BRAUM'S ADDITION

SITE & GRADING PLAN
B.J.T. LEWIS SURVEY, ABSTRACT NO. 225
CITY OF ROCKWALL, ROCKWALL COUNTY, TEXAS

BRAUM'S SITE PLAN
ADDITIONAL INFORMATION

Agenda Item: P&Z 91-20/SP/FP/CUP - Hold Public Hearing and Consider Recommending Approval of a Request from Braum's for a Conditional Use Permit for a Structure with Less than 90% Exterior Masonry Facade, a Site Plan and Final Plat on a Tract of land Located on Yellowjacket and SH-205

BRAUM'S ADDITION	
B.J.T. LEWIS SURVEY, ABSTRACT NO. 225	
CITY OF ROCKWALL, ROCKWALL COUNTY, TEXAS	
Braums Ice Cream Company P.O. Box 25429, 3000 N.E. 63rd, Oklahoma City, Oklahoma, 73125 Tel. 405-478-1656	Owner

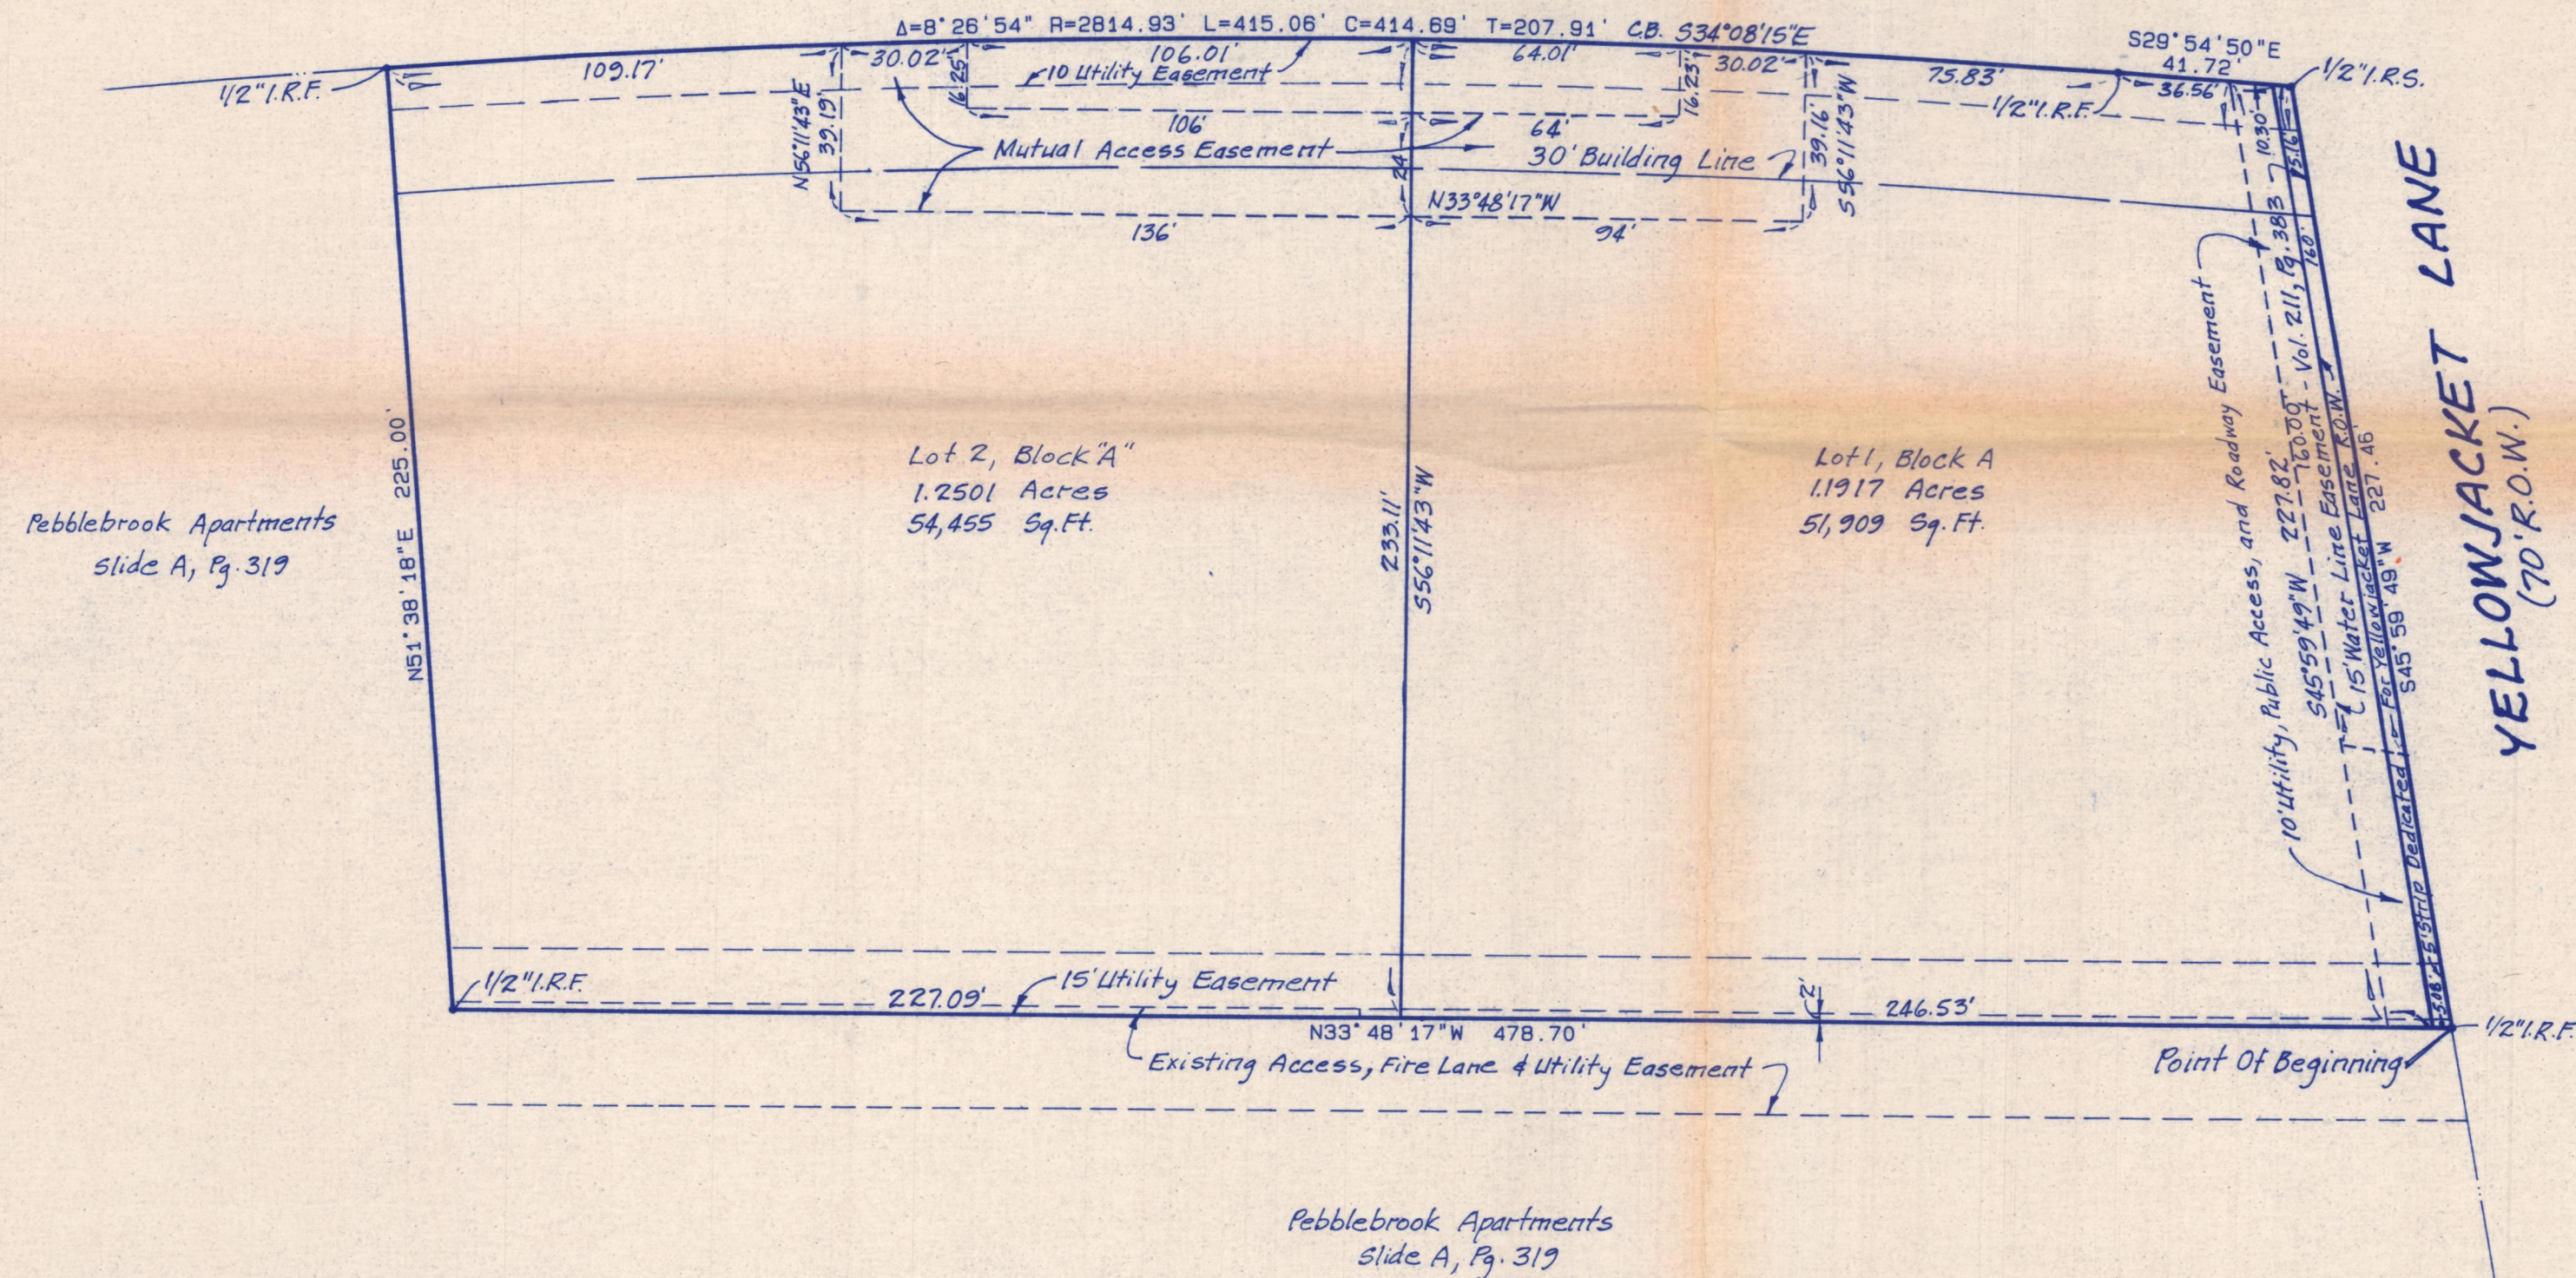
The changes needed to the plat include:

1. The extension of the utility, roadway, and access easement along the full length of Yellowjacket.
2. The extension of the mutual access easement on SH-205.

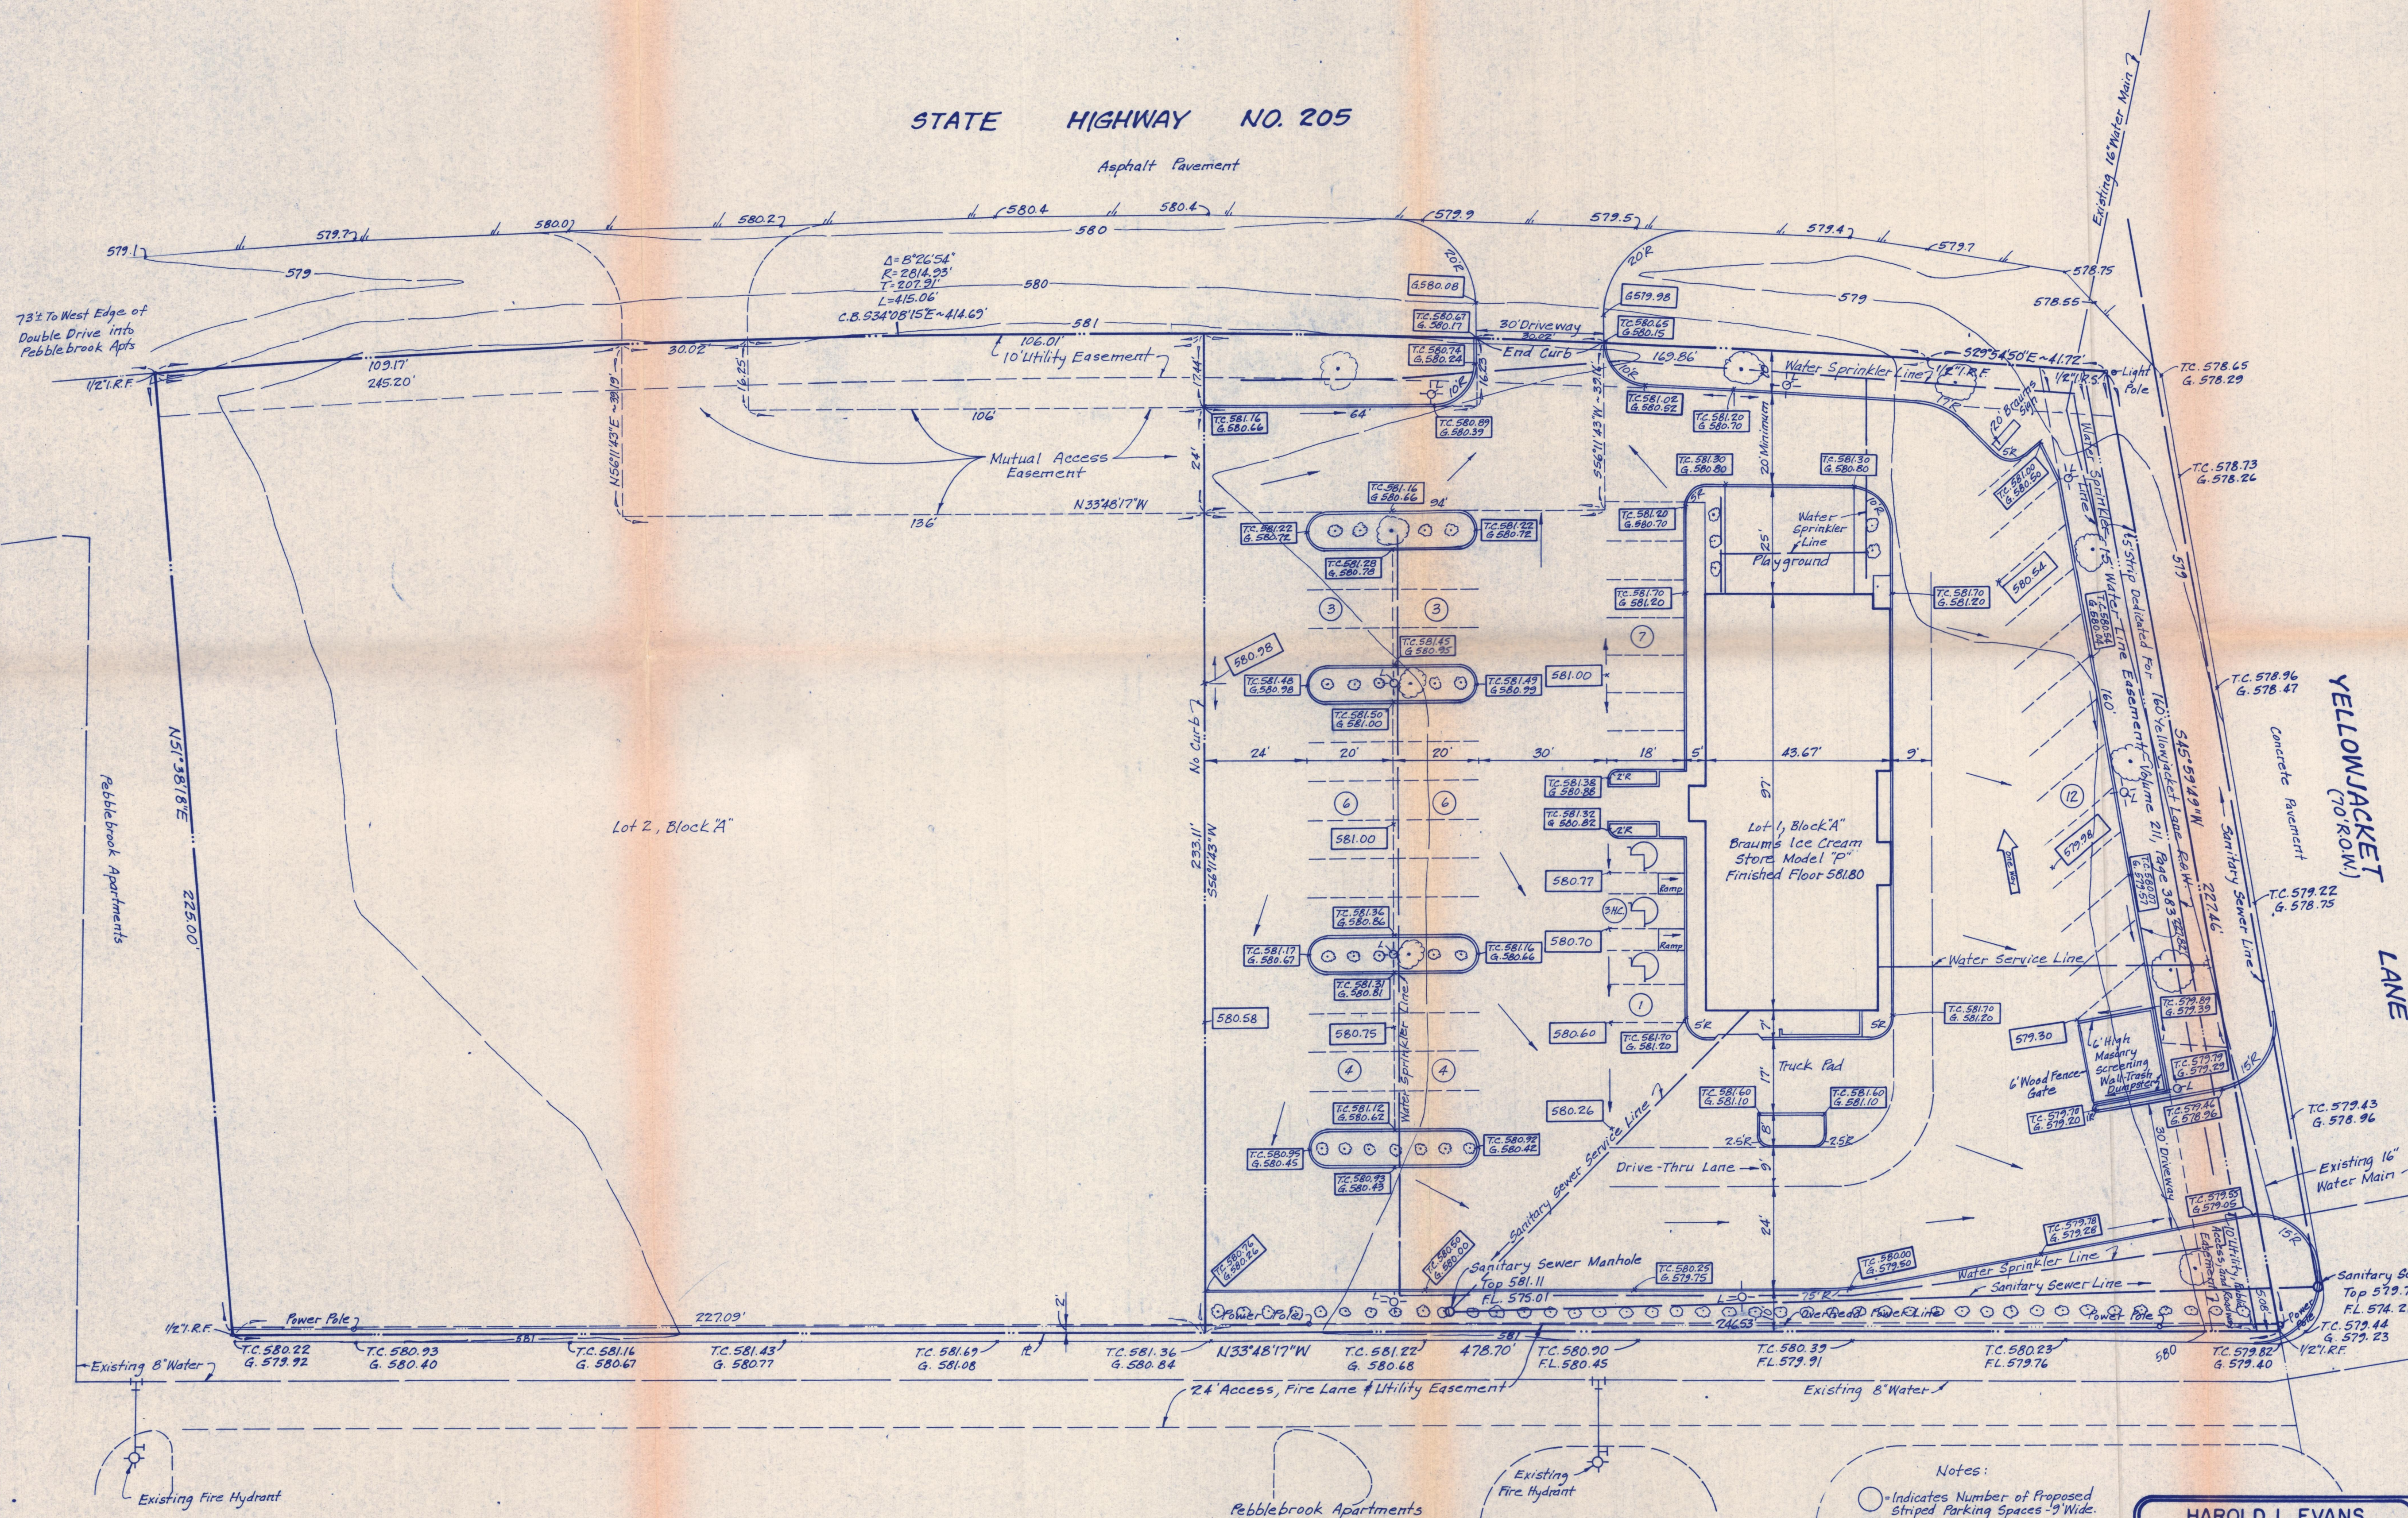
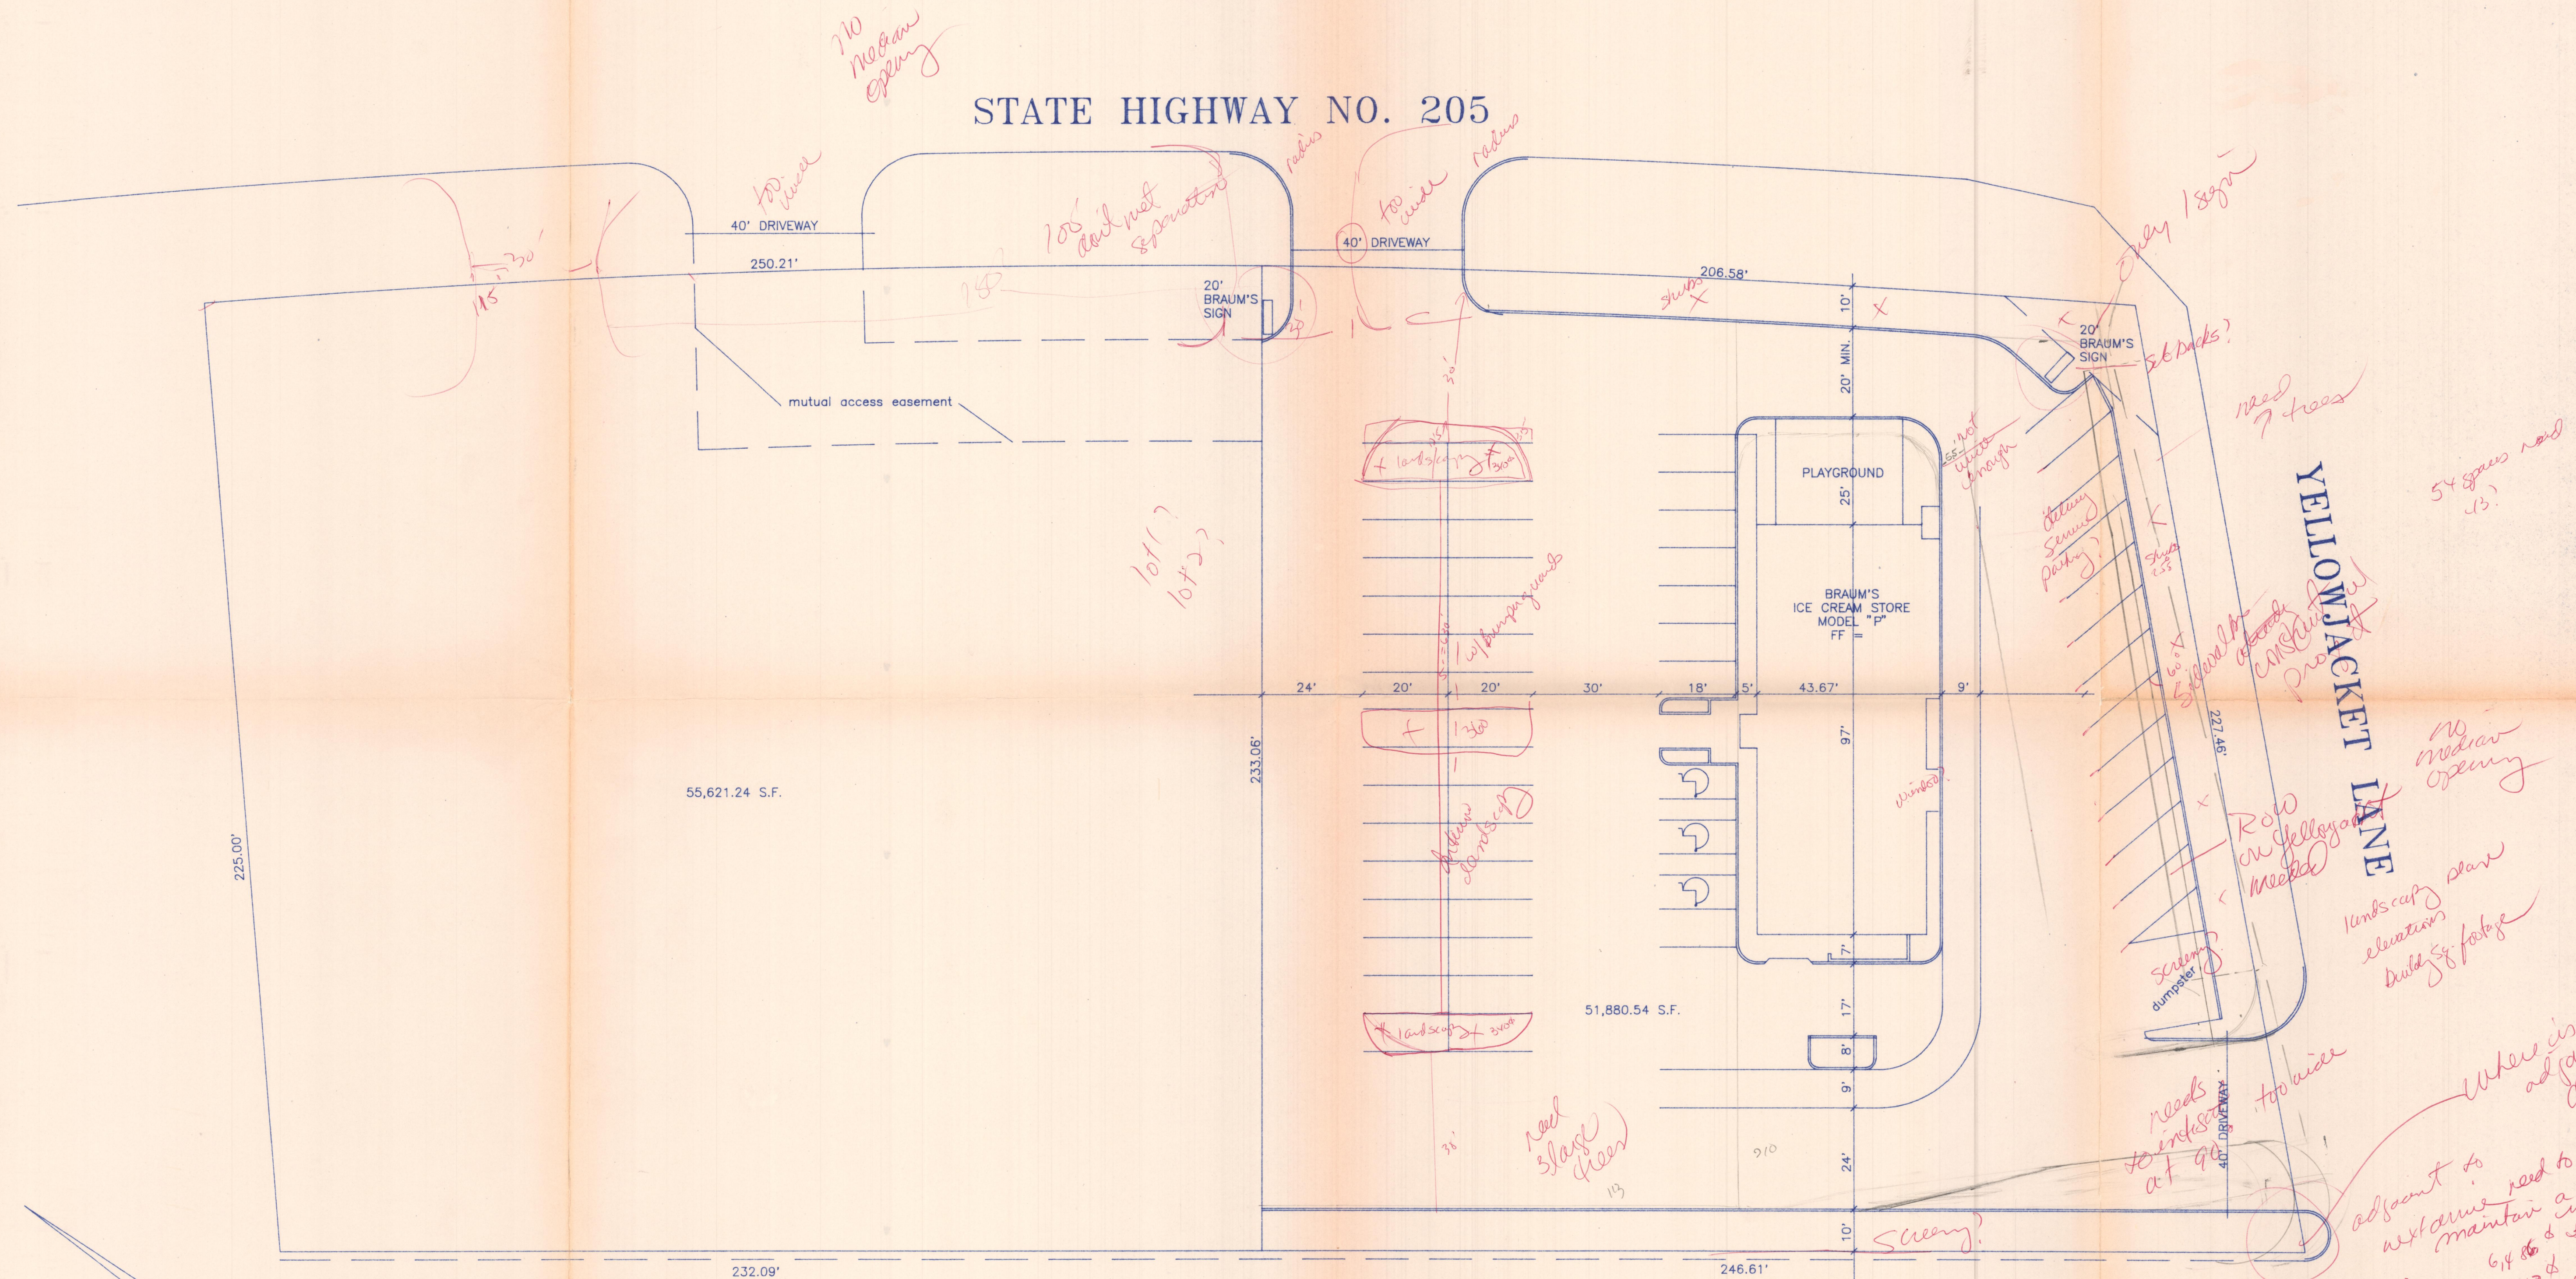
grass in ROW + sprinkler system out in this area

Parkly lot \$3,391 + 58 = 1,169 \$
have
~~700~~
need add island & curbs for walkway
need 275

total site = 31,909 \$ 15% = 7786
total landscaped = 7324
need 460

need 3 trees in parking lot

Screening wall needs to be of same material as building - would be better w/ metal doors on screening wall

do not enter at front of building mine

Grading plan needs to be approved by C.E.

drives need to be further apart - 170' apart inside
to inside

Extend roadway + access + utility along Yellowjacket

The following items are those changes that still need to be made to the site plan and plat for the proposed Braum's location:

1. An additional 275 sq. ft. of landscaping is needed in the parking lot.
2. A total of 3 trees need to be added to the parking area. The final location of the trees on Yellowjacket need to be decided prior to planting.
3. An additional 460 sq. ft. of landscaping is needed on the site.
4. The drives located on SH-205 need to be at least 170 feet apart.
